UNITED STATES PATENT AND TRADEMARK OFFICE

10/080,933

Office Action Summary	Application No. 10/080,933	Applicant(s) ZHANG ET AL.	
	Examiner Jean B. Corrielus	Art Unit 2611

DETAILED ACTION

Zangi's Fig. 3

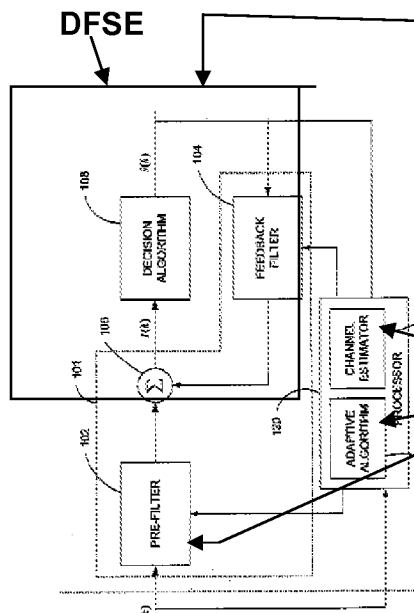
11. Applicant's arguments filed 3/19/09 have been fully considered but they are not persuasive. It is alleged that four separate structural elements are claimed while Zangi only teaches three structural elements. This is inaccurate. Examiner maintains that at least Fig. 3 of Zangi shows the corresponding claim features. As shown in the diagram below, each of applicant's claimed feature, shown, for instance in fig. 2, corresponds one to one to each of Zangi's components shown at least in fig. 3. The DFSE circuit of Zangi (see diagram below), corresponding to applicant's claimed limitation "DFSE", includes a summer 106, a feedback filter 104 and a maximum likelihood sequence estimator 108. In addition, the adaptive algorithm 124 of Zangi corresponds to signal optimizer, shown in applicant's fig. 2, as block 74. Zangi further teaches a channel estimator 122, shown in applicant's fig. 2 as 54. Zangi teaches a prefilter 102 corresponding to applicant's circuit block 56 depicted in fig. 2. Since Zangi teaches every feature of the claimed invention, i.e., structurally and functionally, as depicted in the above rejection, and further, as shown in the mapping below, Zangi anticipates the claimed invention.

Fig.2 of current Application

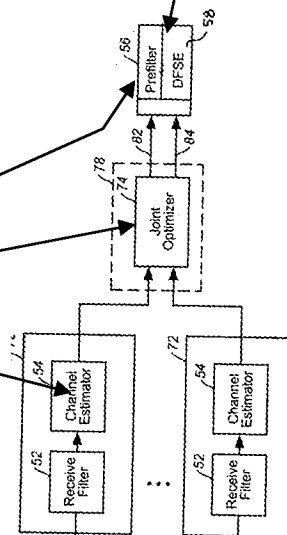
1. The drawings are objected to under 37 CFR 1.83(a) because they fail to show a signal input from the signal estimator to the “joint optimizer”, shown in fig. 3, as described in the specification page 12, lines 7-8 and fig. 23. as evidence by fig. 2, the signal optimizer is configured to receive an input from the channel estimator. In addition, fig. 3 is the expanded view of elements 74 and 56/58 shown in fig. 2. Fig. 2 only shows signals 82 and 84 feeding components 56/58 while fig. 3 shows signals 53, 82 and 84 feeding circuit 56/58. In other words, base fig. 2 does not show any signal “53” being provided to circuit 56/58. Any structural detail that is essential for a proper understanding of the disclosed invention should be shown in the drawing. MPEP § 608.02(d). Corrected drawing sheets in compliance with 37 CFR 1.121(d) are required in reply to the Office action to avoid abandonment of the application. Any amended replacement drawing sheet should include all of the figures appearing on the immediate prior version of the sheet, even if only one figure is being amended. The figure or figure number of an amended drawing should not be labeled as “amended.” If a drawing figure is to be canceled, the appropriate figure must be removed from the replacement sheet, and where necessary, the remaining figures must be renumbered and appropriate changes made to the brief description of the several views of the drawings for consistency. Additional replacement sheets may be necessary to show the renumbering of the remaining figures. Each drawing sheet submitted after the filing date of an application must be labeled in the top margin as either “Replacement Sheet” or “New

2. The drawings were received on 3/19/09. These drawings are not acceptable for the reasons set forth above. In addition, Optimizer should be labeled as “74” as oppose to “72”.

With respect to the drawing, applicant stated that replacement sheet corrects the deficiencies noted in the outstanding drawing objection. However, the changes noted in the comment are not in the drawing (replacement sheet). Fig. 3 only shows the output of the optimizer being provided to the prefilter and DFSE 56/58. However, fig. 3 shows a signal 53 being provided to the prefilter. This not consistent with fig. 2.
